Appendix 11

Barton Greenway Review

Nigel Brigham & Associates

Cambridgeshire
County Council

• **Barton Greenway Map 12**

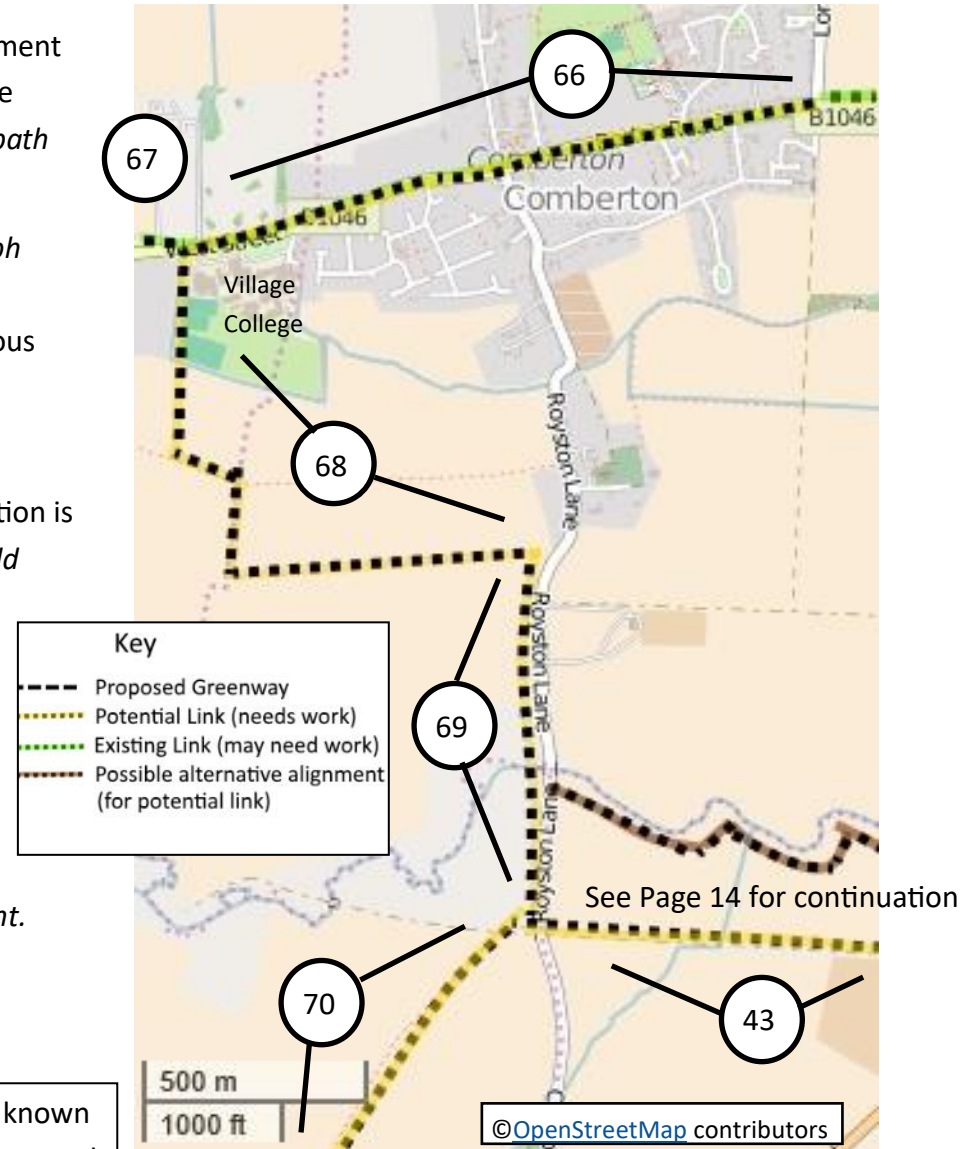
63. Over this length, in front of housing, the path is constrained by a ditch on one side and carriageway on the other leaving a 1.4m path with no verge, which is not up to standard. The path could be widened over the ditch by piping or bridging the ditch, but this brings it closer to the properties and the preferred option is to widen it by moving the carriageway edge south. *Widen path to 2m min + verge by moving carriageway northern edge south. Remove central hatching and re-align road by Horizon Park entrance.*

64. Existing path not up to current standards, apart from at Comberton end. The path narrows due to constraints of ditch and parapets. Path width drops to 1.1m, with no verge. *Construct new path in field edge behind ditch 2.5m wide. Subject to landowner's agreement.*

65. The existing crossing arrangement for cyclists diverts them up Long Road and is an unsatisfactory arrangement that few would use. *Add raised crossing and consider cycling zebra to east of mini roundabout so that cyclists from Comberton cross the mini roundabout and then turn on to the off-road path and vice-versa. Crossing to act as a Gateway for the village.*

66. On road route through village centre. Ideally *the road should be designated 20 mph with appropriate traffic calming if needed.* Consider removing central line and resurfacing with a different colour finish as well as adding raised platforms at various locations.

- **Barton Greenway Map 14 Eversdens Links**

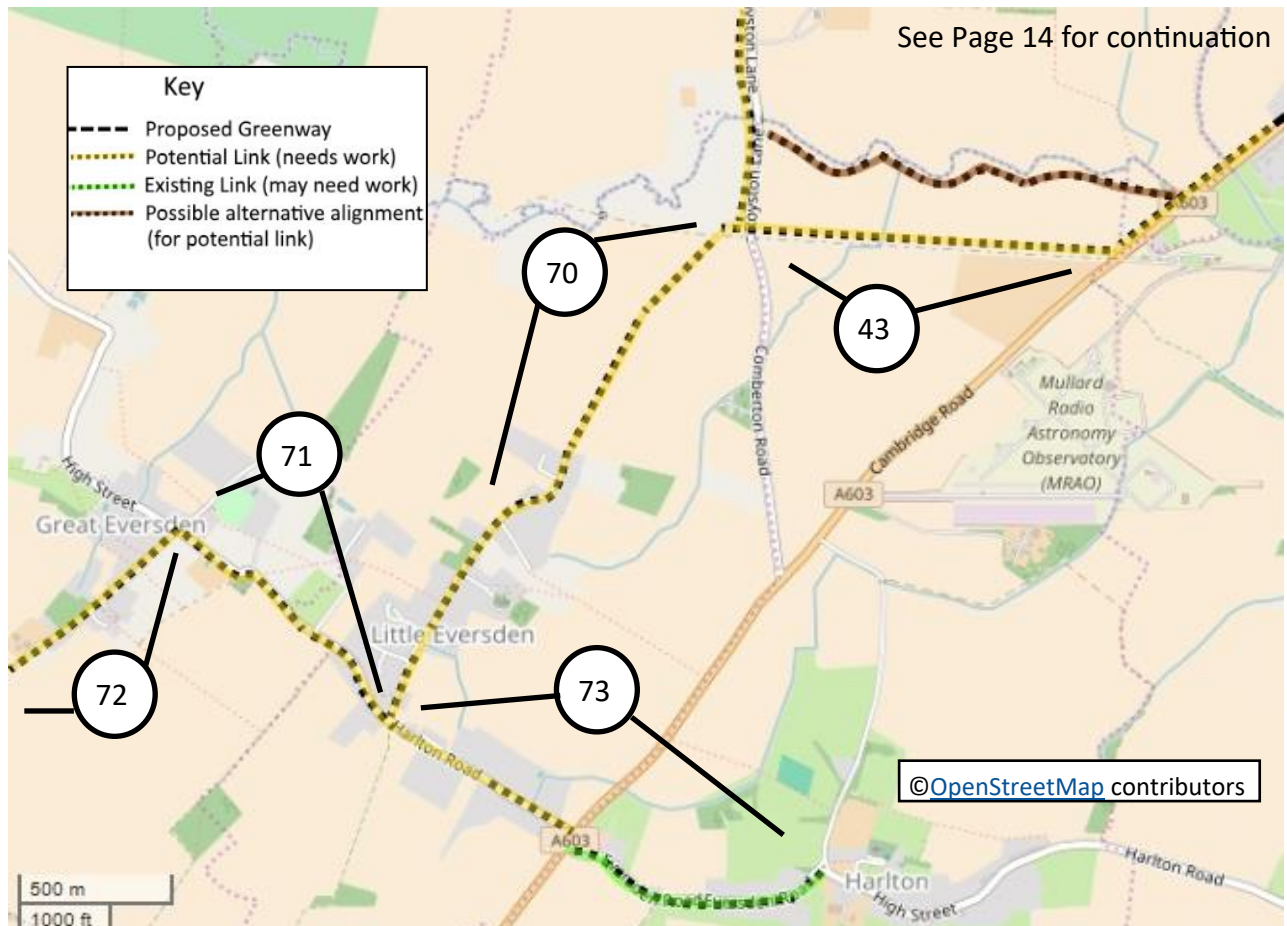
43. For onward link between the A603 corridor and the Eversdens landowner’s agreement will be needed to construct a field edge path. The best alignment would follow the disused railway/ radio telescope alignment, but there are alternatives. *Construct path between Royston Lane and A603, subject to agreement.*

70. Route following field edge/ public footpath. Not surveyed, but known to have been discussed in the past. *Construct path to Little Eversden, subject to agreement. Potential to accommodate horses/ bridleway usage to be considered.*

71. If a route is developed for Little Eversden a good link with Great Eversden will be important. The existing road is a concern. *Review options for good link with Great Eversden and undertake necessary works.*

72. Potential route to Wimpole Hall. This has been examined in the past and was the subject of a funding bid many years ago. Works are needed but there is potential for a good link with the Wimpole Estate (National Trust).

73. If a route is developed for Little Eversden a good link with Harlton and Haslingfield will be important. The existing road is a concern and the A603 crossing is also a concern. *Review options for good link with Harlton and undertake necessary works.*
